THE BICYCLE INSTITUTE OF SOUTH AUSTRALIA

4 July 2016

Levels-City Bikeway: Regency Road crossing at Galway Terrace

1.1 Kerb ramp to path

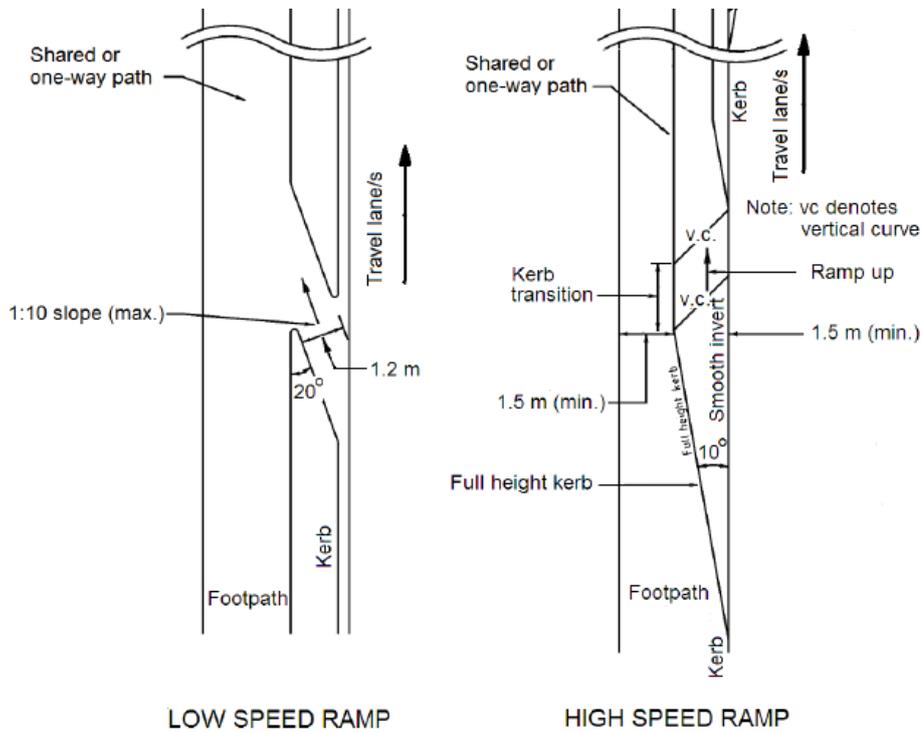
For over a decade, DPTI has insisted on using an entry kerb ramp design that contradicts Australian design guidance – currently Austroads’ *Guide to Road Design: part 3: geometric design* (as per Figure 4.25); previously Austroads’ *Guide to Traffic Engineering Practice Part 14: bicycles* in either the original 1996 version or second edition published in 1999. This also contradicts South Australian guidance, which follows Australian guidance except where specifically noted, and as kerb ramps are not a specifically noted exception.

Very simply, to enter a kerb ramp aligned at 90 degrees to the road, a cyclist must swing out into traffic – as shown indicatively in the sketch at right.

This can easily be checked for intuitive sense: at 90 degree intersections, cycle paths should have a minimum splay radius of 2.5m, as per figure 7.13 in *Cycling Aspects of Austroads Guides* (AP-G88-14). A bike lane adjacent to the kerb is less than 2.5m in width, so there isn’t enough space to easily conduct this turn.

For Galway Terrace, this isn’t as bad as at other places (as long as a cyclist doesn’t follow the line of the bike lane), because the bike lane is slightly away from the kerb. However, the swinging out would occur at the same point where left-turning cars are wanting to tend to the left, and drivers would not expect a cyclist to veer into their path of travel. This creates a conflict between motorist and cyclist travel paths, with little opportunity for either party to manage this.

As the path is bike-only, pedestrian use would be low. While the proposed situation is not identical to the guidance situation, Figure 4.10 shows that a kerb ramp for low speed exit from a road should be aligned at an angle of some 20 degrees to the roadway.

If DPTI does not do this, it should prepare a traffic impact statement outlining the reasons for ignoring this design guidance. We would like to see this justification, addressing our points outlined above. We would also like a road safety expert's opinion of this and note that in the absence of either of these, we would contend that DPTI is liable in the event that a cyclist swinging out into traffic is hit by a car, in this or any other similar location.

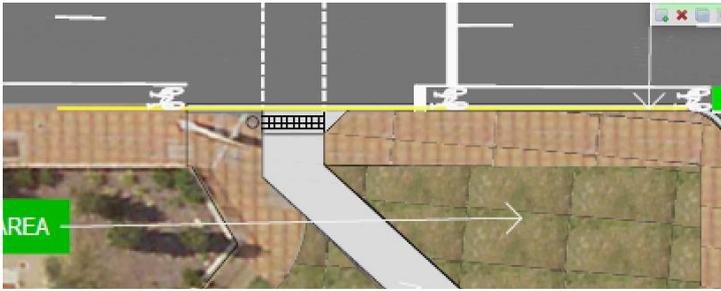
If DPTI still insists on this unsafe measure, we plead with DPTI to implement an ameliorating treatment by locating the bike lane further away from the kerb to provide an adequate turning circle and a kerb protuberance to encourage drivers to position further right until they have passed the conflict area – as per the following sketch (the red arrow shows how this accommodates the left turn manoeuvre).

1.3 Right turn, Regency Road to Beaven Avenue

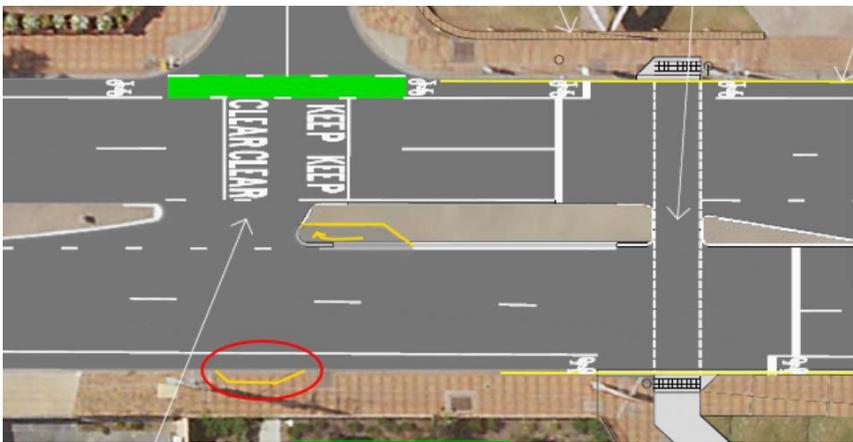
Not all cyclists will be coming from Galway Terrace. We would like to see provision for cyclists to turn right into Beaven Avenue, with a short right turn bike lane in the median and a turning bay on the kerbside providing different options depending on traffic flows. These also provide options for experienced and confident cyclists from Galway Terrace wanting to access Beaven Avenue without having to use the PAC.

1.4 South-east corner Regency Road/ Galway Terrace

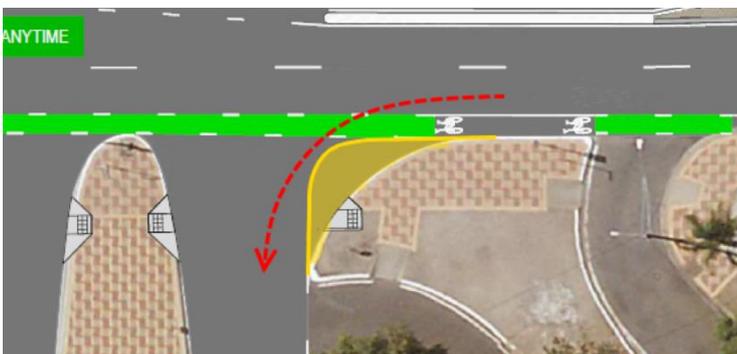
The kerb radius at this corner is very large. This encourages high speeds for drivers turning left from Regency Road, across through cyclists using the bike lane in Regency Road, and into Galway Terrace. We can see no good reason for such a wide kerb radius.

We would like to see this kerb built out. The following sketch indicates the effectively large turn radius that would remain, due to the generous width of the Galway Terrace travel lane and the space provided by the bike lane. It would be positive if this could be reduced further.

Proposed Option 3

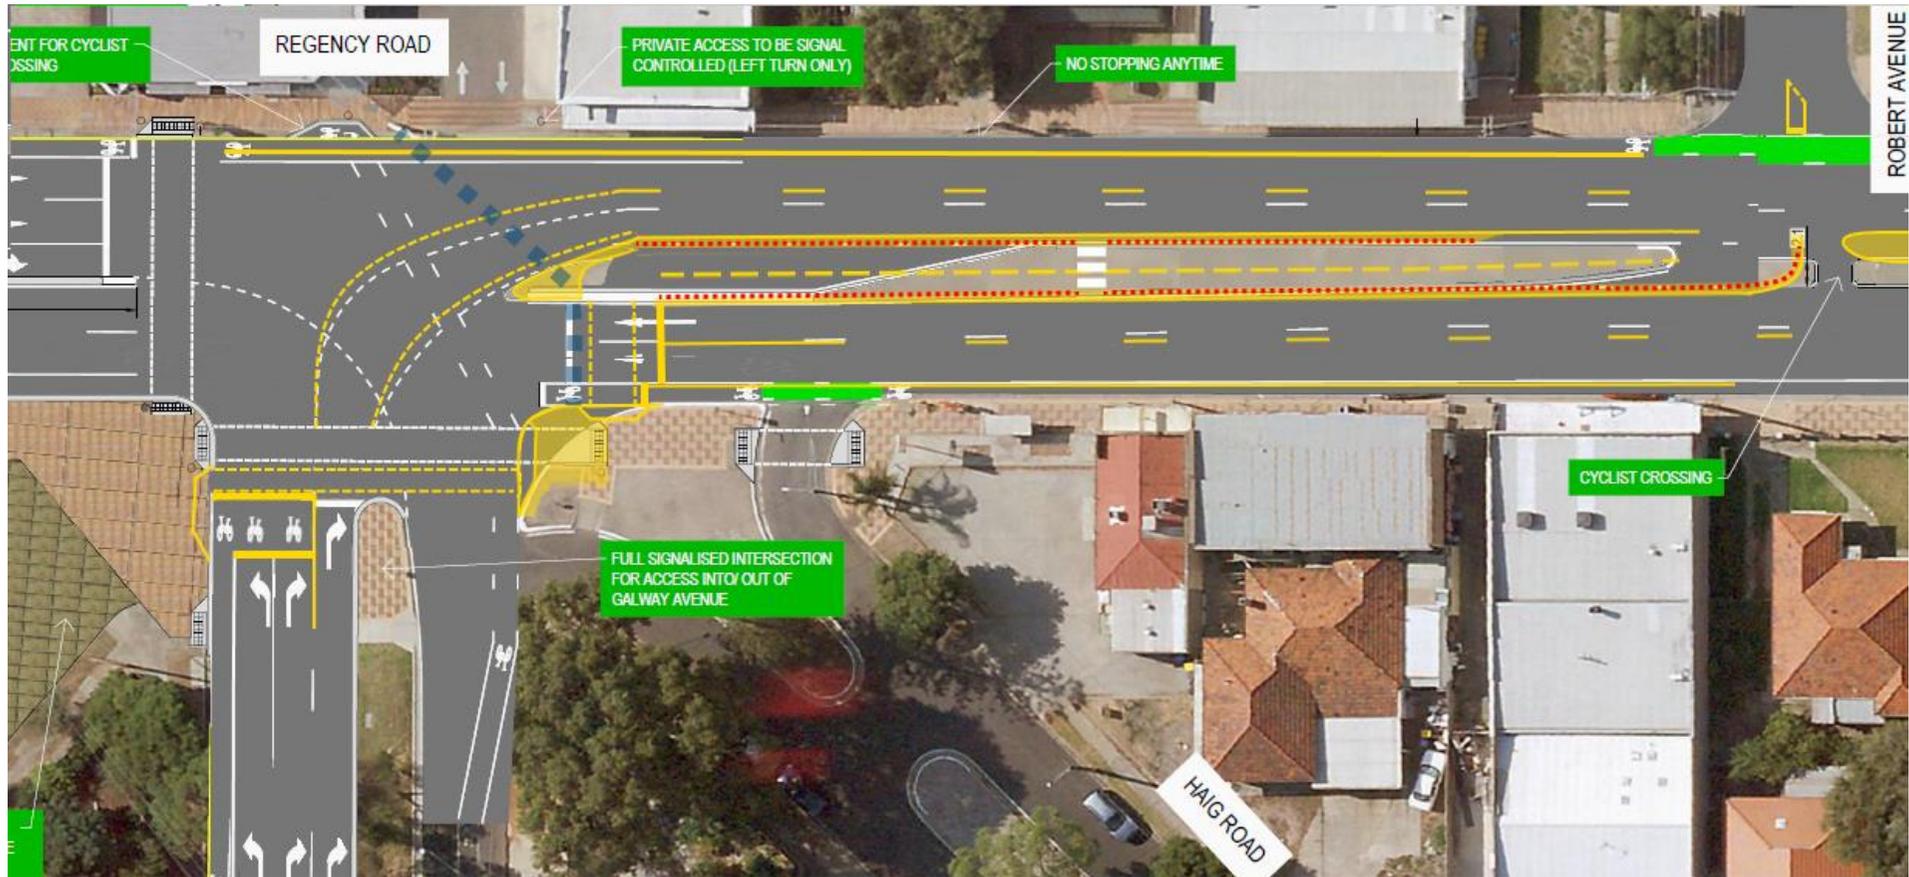
This assumes the following finessing of travel lane widths:

- Southern (westbound) side of Regency Road: options 1 and 2 both show a kerbside travel lane of about 3.7m and median-side lane of about 3.3m. Currently, the respective lane widths are 3.6m east of Robert Avenue reducing to 3.5m at the start of the median and down to 3.4m at the bus stop; and 3.1m. Given that under option 3 these lanes will be on the approach side of a set of signals, where lower speeds should be expected, a 3.4m kerbside and 3.1m median-side lane should be sufficient.
- Northern (eastbound) side of Regency Road: the kerbside travel lane is currently 3.5m wide, a generous width allowing for the car parking on the northern kerb. Under option 2, this parking (which we believe is mainly used for drop-offs) is no longer allowed. With this restriction, and given that there is an adjacent bicycle lane, a width of 3.1m should be plenty for this travel lane.

This gives a total available median space at the western end of some 4.2m (comprising 0.4m released from kerb side lane; median-side lane increased from 3.0m to 3.1m as it's now against a constructed kerb; existing acceleration area within the median of 3.4m no longer required for buses; 0.5m back-to-back kerb allowance) and at the eastern end of 3.2m (comprising 0.4m released from kerb side lane; current median width of 2.7m; and 0.1m released from standardising the kerbside lane at 3.4m).

This is more than wide enough at the western end but still narrow at the eastern end for a 3.0m path between fencing installed in back-to-back kerb. We suggest that a narrower path width would be acceptable, especially as the total path length would be some 80m and the minimum width would apply for only about half of this length. Also, experienced cyclists could use the bike lanes on Regency Road, with only those cyclists wanting greater protection using the median path.

We would prefer a minimum width between fences of some 2.5m but note that the effective width (i.e. width between edge lines, once a clearance line to the fence is marked) would be narrower than this. This is acceptable under Austroads guidelines.

With a formalised central median path, the signalisation of option 2 should be extended to providing access to the median path. This could run in conjunction with the left and right-out phase with no impact on traffic, and the right-in phase provided for cyclist right turns in, again with no impact on traffic.
